UNIVERSITY OF VIRGINIA
NUCLEAR REACTOR FACILITY

Re: Proposed amendment to CAVALIER Technical Specifications, in conformance with
NRC's Request for Additional Information (TAC No. MA8249) of February 25, 2000
[CAVALIER License No. 123, Docket No. 50-396]

FACILITY LICENSE R-123

CAVALIER REACTOR

FIGURE 6.1 "A"
ORGANIZATIONAL CHART
UNIV. OF VIRGINIA NUCLEAR REACTOR FACILITY
(PRIOR TO SHIPMENT OF ALL FUEL ELEMENTS OFF-SITE)

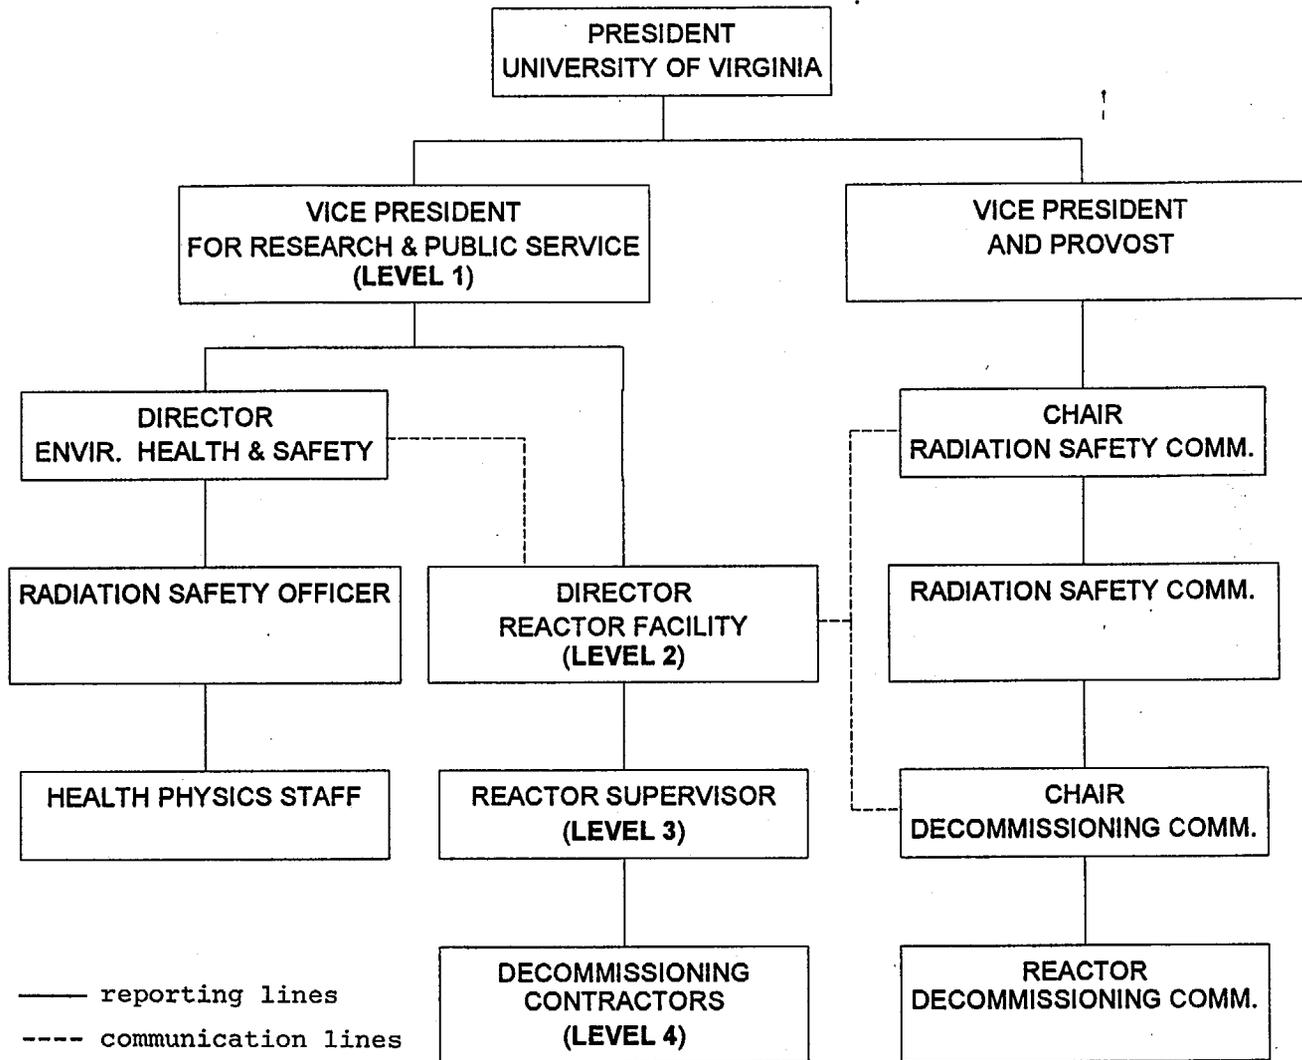
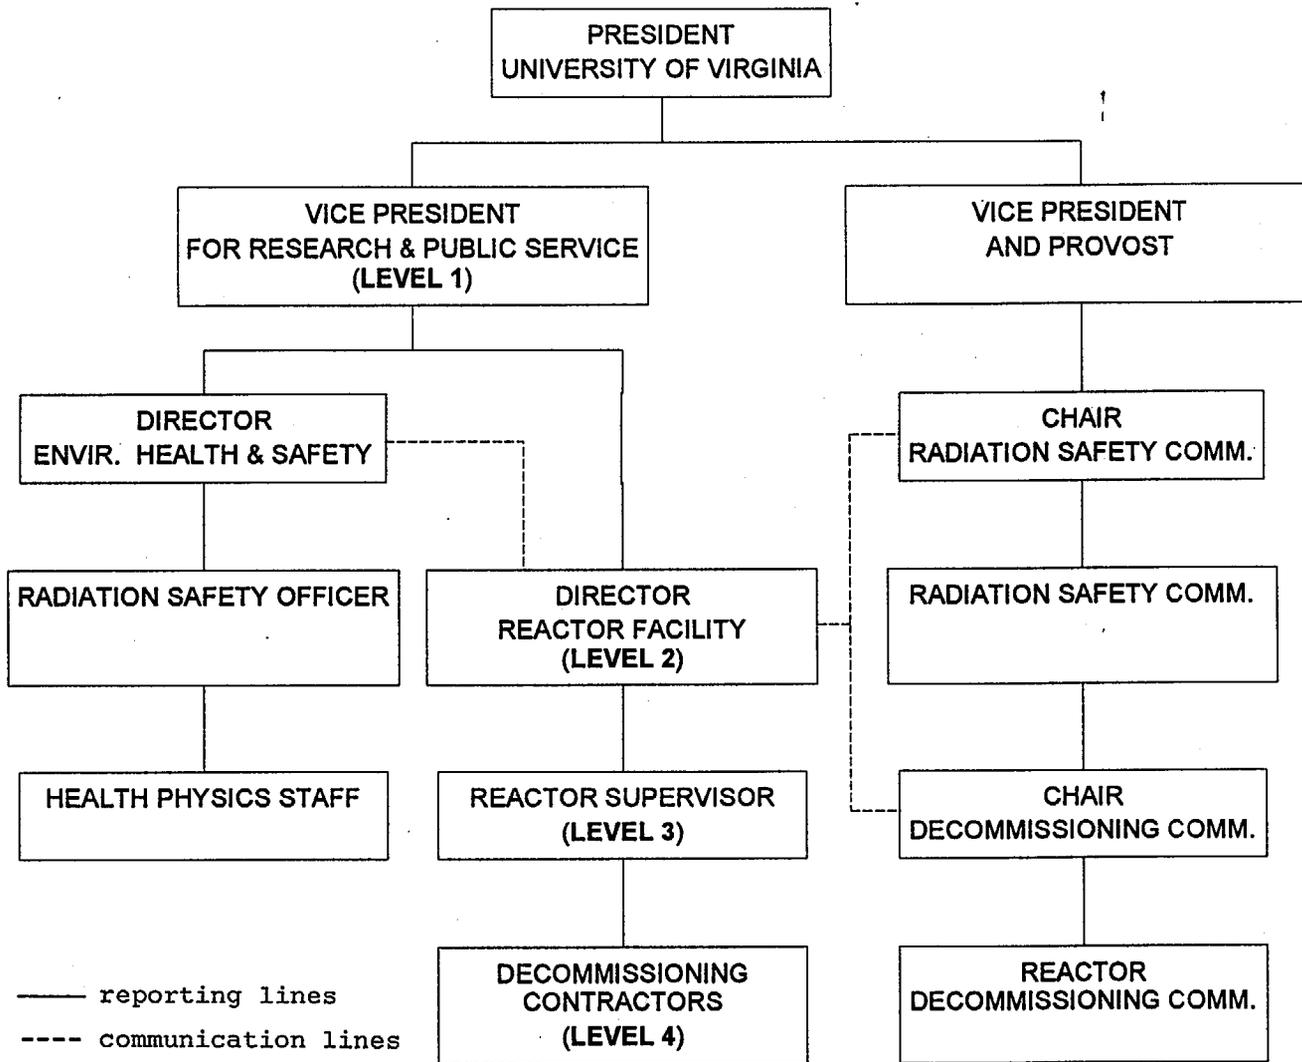
The Reactor Facility shall be an integral part of the University of Virginia. The organizational structure of U.Va. relating to the Reactor Facility is shown in Figure 6.1. The Vice President for Research and Public Service (Level 1) shall have overall responsibility for management of the Facility. The Reactor Decommissioning Committee Chair shall be responsible for advising the Reactor Director (Level 2) on all matters pertaining to the decommissioning and decontamination of the University of Virginia Reactor Facility. The decommissioning committee members may include reactor staff from Level 3, and employees from the Office of Environmental Health and Safety.

A licensed Senior Reactor Operator shall supervise any movement of reactor fuel. One or more health physicists, organizationally independent of the Reactor Staff as shown in Figure 6.1, shall be responsible for radiological safety at the Reactor Facility.
